SUBJECT: Advises that mods to recirculation pump trip sys
 implemented during 1990 spring refueling outage.

Subject: NUCLEAR PLANT NO. 2, OPERATING LICENSE NPF-21
ANTICIPATED TRANSIENTS WITHOUT SCRAM (ATWS) -
DESIGN MODIFICATIONS (TAC No. 59158)

ATWS/RPT Coincident Logic

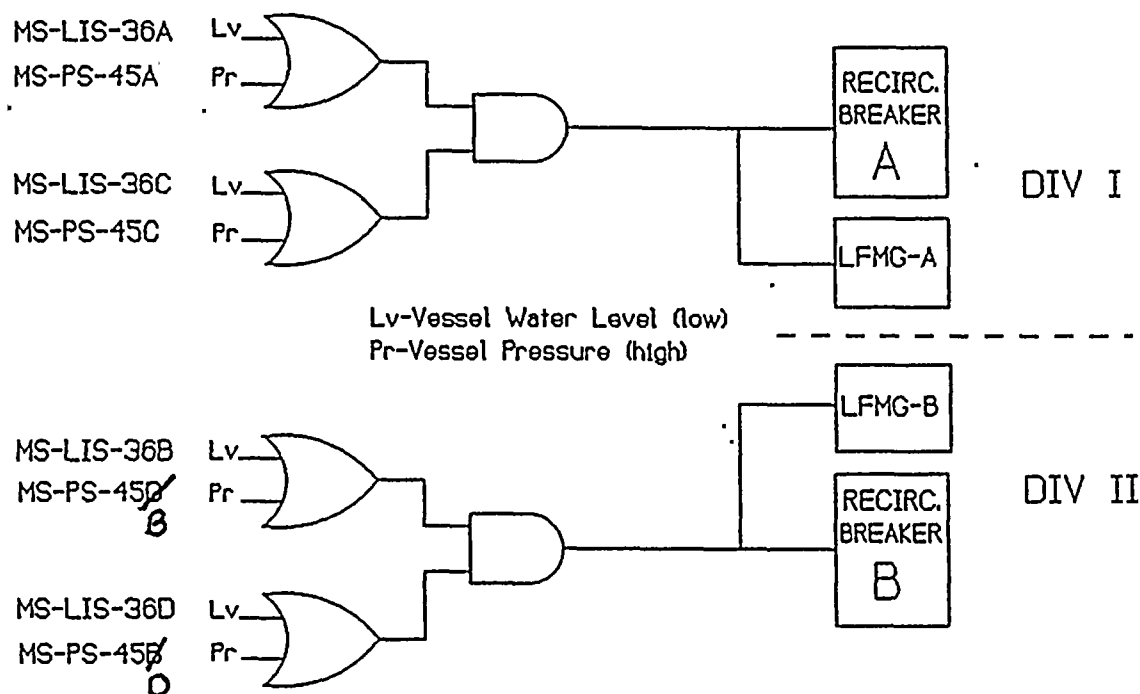
- The ATWS-RPT system has been modified to provide the RPT pump trip logic shown in the attachment to this letter. Changes from that proposed in Reference 2 are noted. These changes have no impact on the resolution of the concern raised by the NRC in Reference 5.

The proposed coincident ATWS/RPT logic is designed to trip both Recirculation Pumps and trip both low frequency Motor Generator sets during an ATWS event but prevent inadvertent trips. In addition, the logic is designed to be tested during Plant Operations up to the final actuating device prior to the breaker trip coils. Also, this design does not present electrical separation concerns between Division I and Division II.
